Addendum No. 1

RE: Contract # C204182

Dare County (R-5014)

SR 1217 (COLINGTON RD) FROM DEAD END TO US-158 (CROATAN HWY) IN
KILL DEVIL HILLS.

THRUST COLLAR AND THRUST BLOCK NOTES

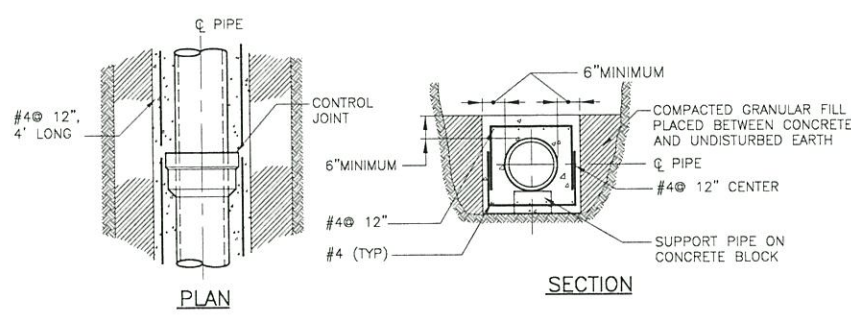
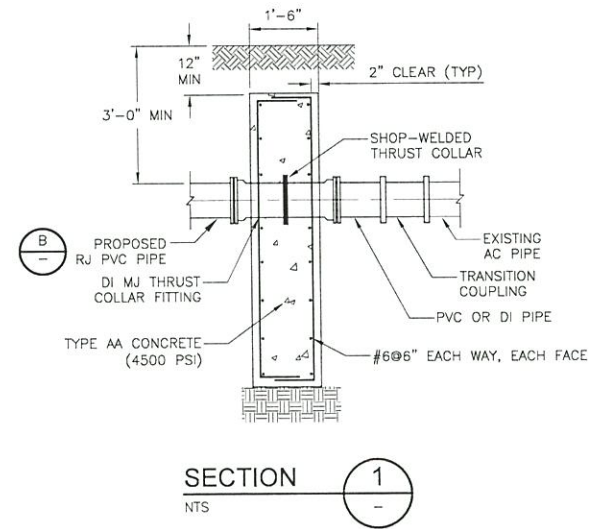
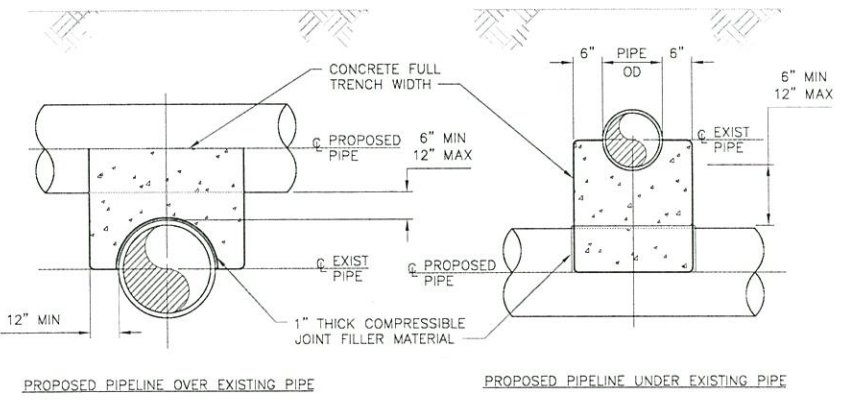
Sheet No.	Revision
UC-3E	Removed notes 4, 5, 7, 8 from the "Thrust Collar and Thrust Block Notes".

REVISIONS
 10-12-21 THRUST COLLAR AND THRUST BLOCK NOTES REVISED BY ADDENDUM
